CERTIFICATE OF APPROPRIATENESS

Applicant: Alexander Ridgeway, Brickmoon Design for Todd and Denise Liebl, owner

Property: 501 Highland Street, lot 16, block 9, Woodland Heights Subdivision. The property includes a historic 1,654 square foot two story residence and two story garage-apartment situated on a 5,000 square foot (50' x 100') corner lot.

Proposal: Alteration – Revision. The applicant submitted a COA application for an addition to 501 Highland Street that was considered at the February 26, 2015 HAHC meeting. This proposal involved constructing a two-story addition, replacing the previously existing stucco cladding, and lifting the residence by 11” to install a new foundation. Staff found that the application to not meet criteria 1, 4, 8, and 9 for alterations to Contributing structures. Among the concerns cited, staff found that the addition would be visually incompatible with the smaller existing residence, compounded by the fact that the property is on a corner lot with greater visibility. The proposed lifting of the residence would destroy the front porch and masonry chimney while the house’s original structural shiplap has been removed and destroyed.

LOCATION OF PROPOSED WORK

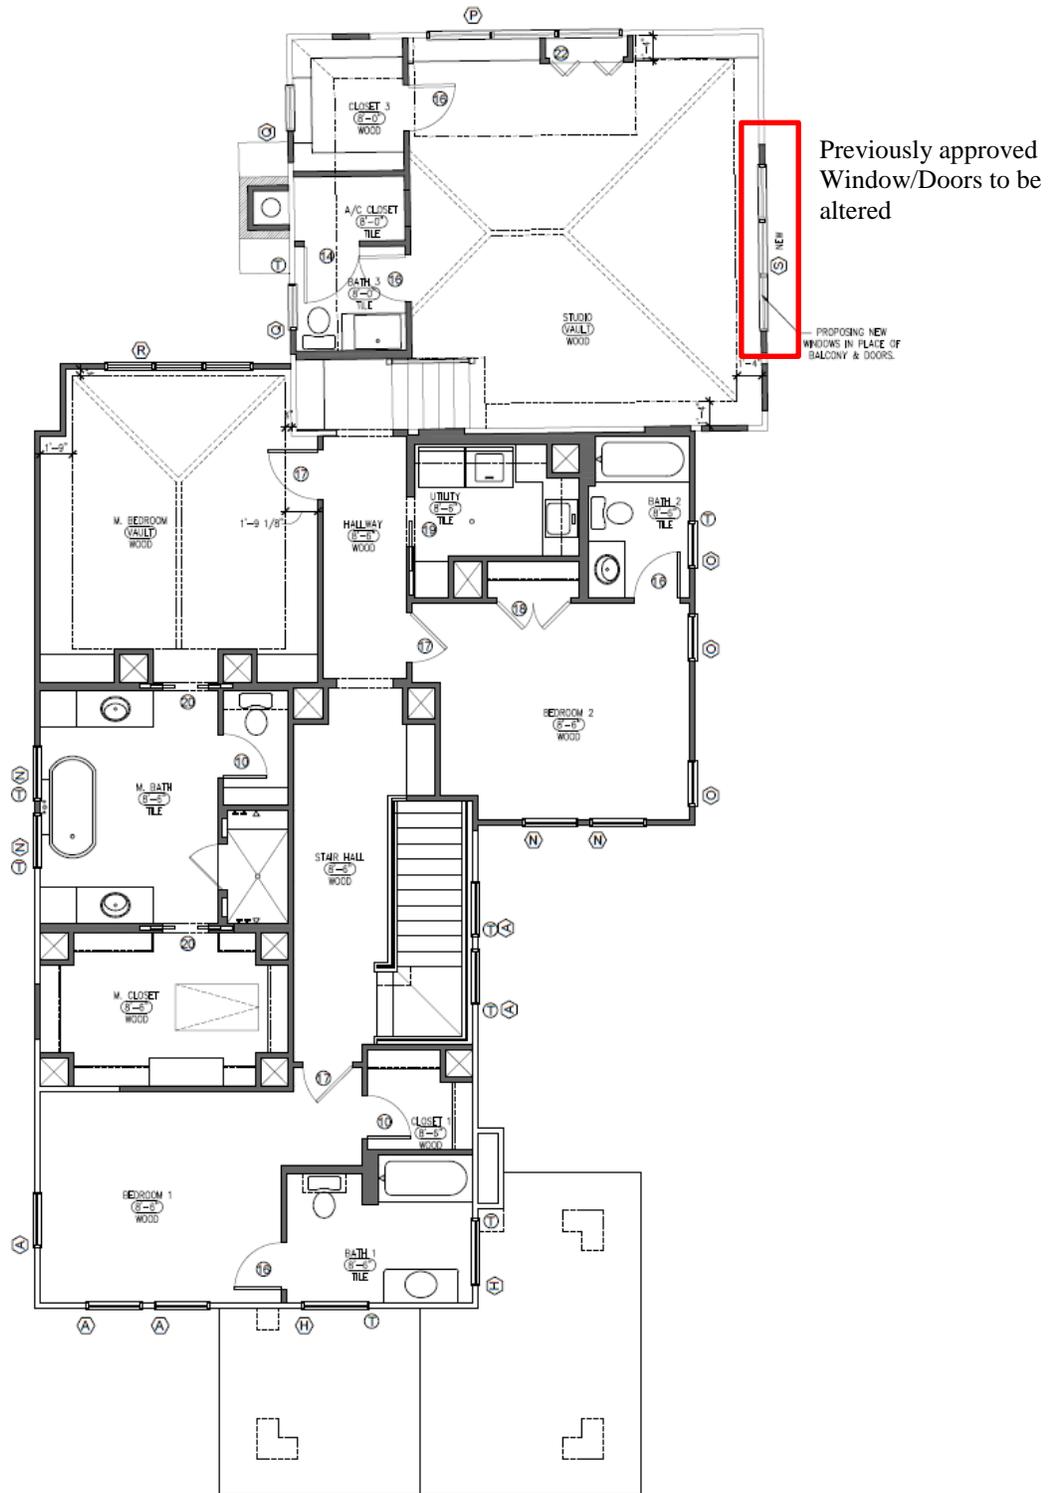
-  Steps to not be constructed
-  Steps to be expanded

PROPOSED WINDOW ALTERATIONS

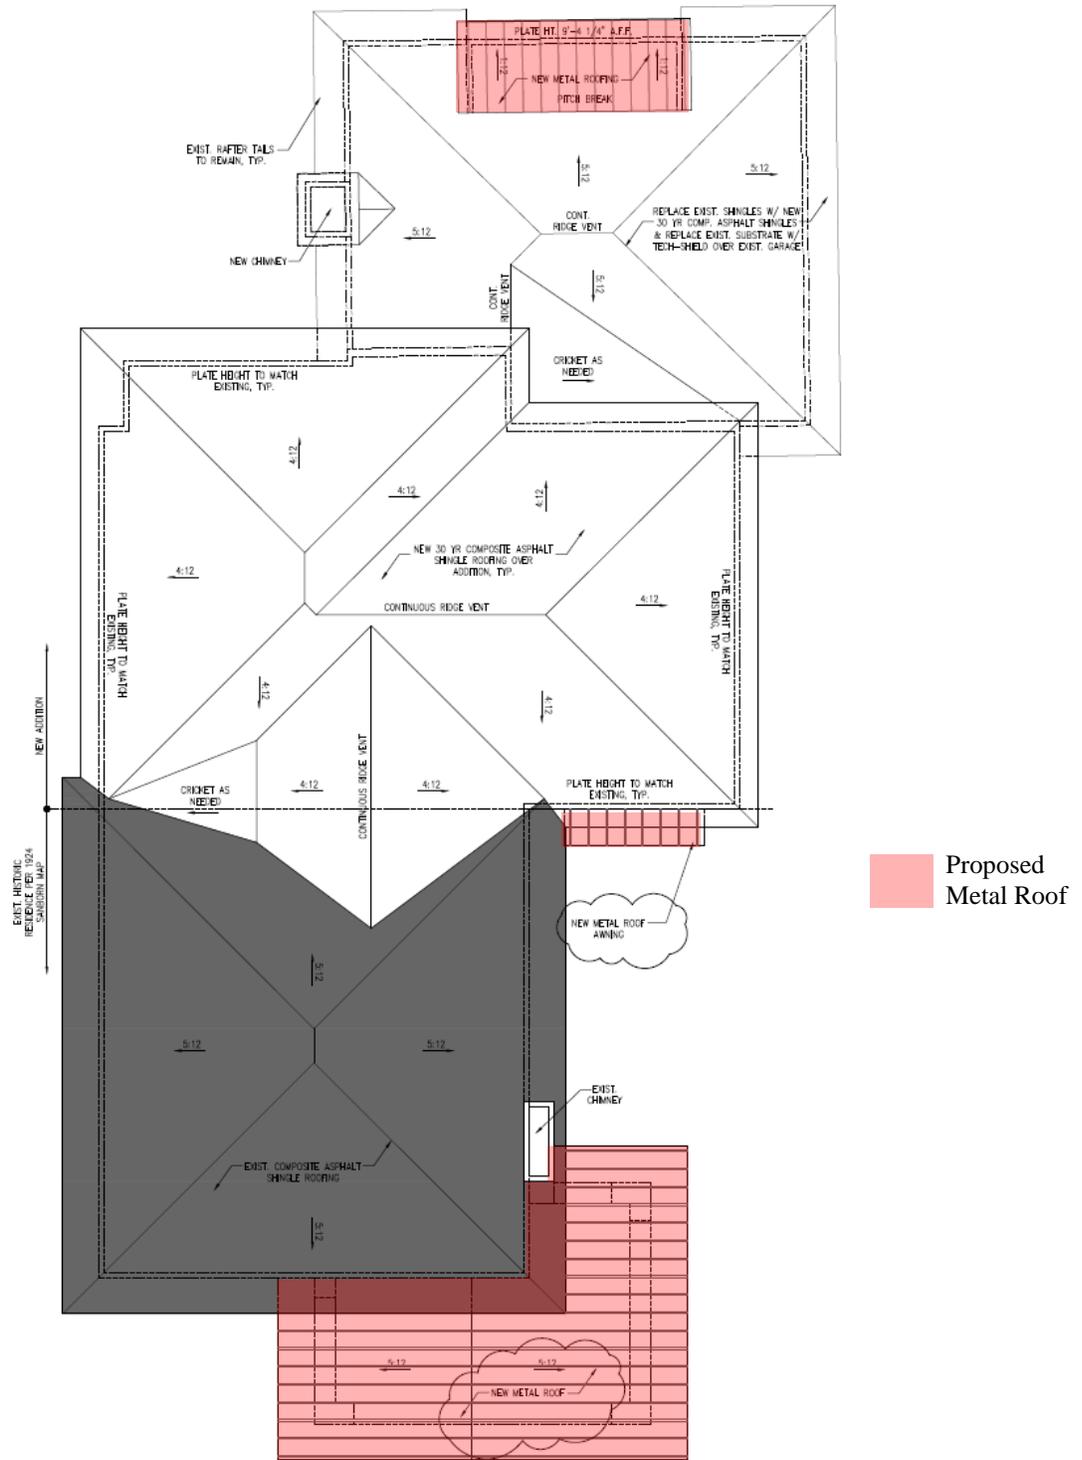
ROOF MATERIAL ALTERATIONS

EAST SIDE ELEVATION FACING HELEN STREET

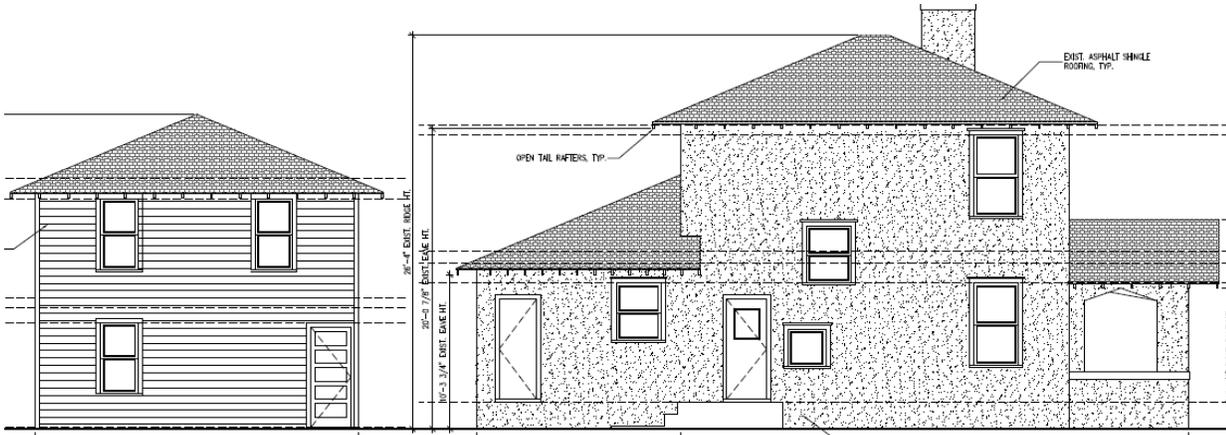
- Delete a proposed second set of steps from the front porch as well as a set of steps leading from the family room to the back patio.
- Delete the proposed small balcony, set of doors, and two windows on the second floor of the garage facing Helen Street, and replace with three aluminum clad windows.
- Extend the previously approved set of steps at the kitchen, and extend the corresponding roof overhang an additional 3'
- Change the roofing material on the new front porch, kitchen step overhang, and rear garage dormer from asphalt shingle to metal

NORTH ELEVATION – FACING REAR

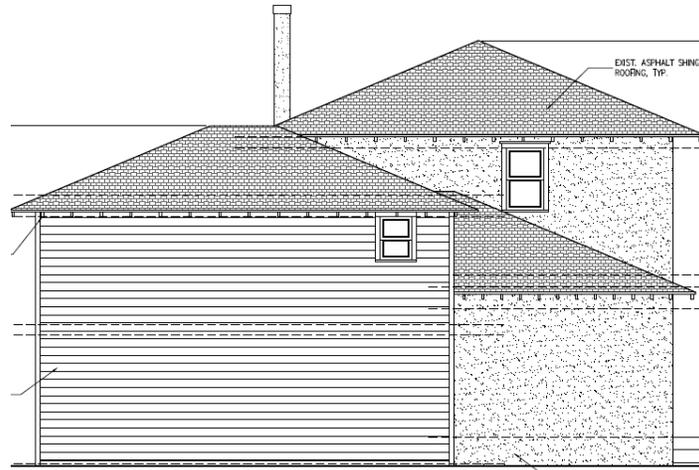
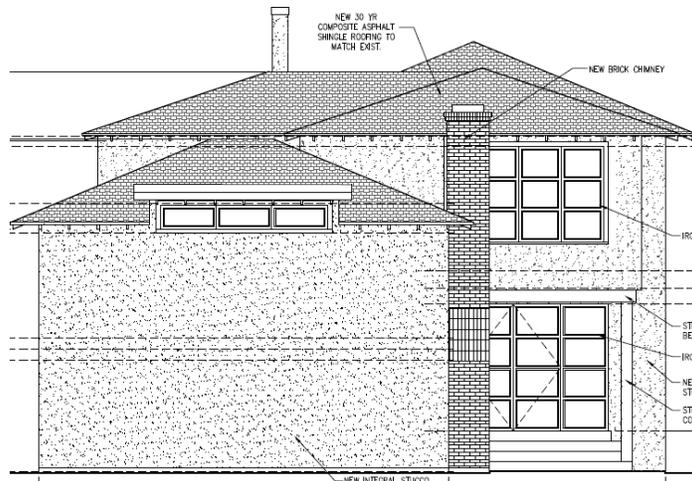
Shape/Mass: February 2016: The applicant now proposes to delete a formerly proposed second set of steps from the front porch (facing the rear) as well as a set of steps leading from the family room to the back patio. The applicant also proposes to delete the small balcony, set of doors, and two windows on the second floor of the garage facing Helen Street, and replace with three aluminum clad windows. The two outer windows will be operable casement windows and the middle will be one fixed window. The previously approved set of steps at the kitchen, and extend the corresponding roof overhang an additional 3'-0". See drawings for more detail.

Roof February 2016: The applicant proposes to change the previously approved composition shingle roofing material on the new front porch, kitchen step overhang, and garage dormer to metal roofing. See drawings for more detail.
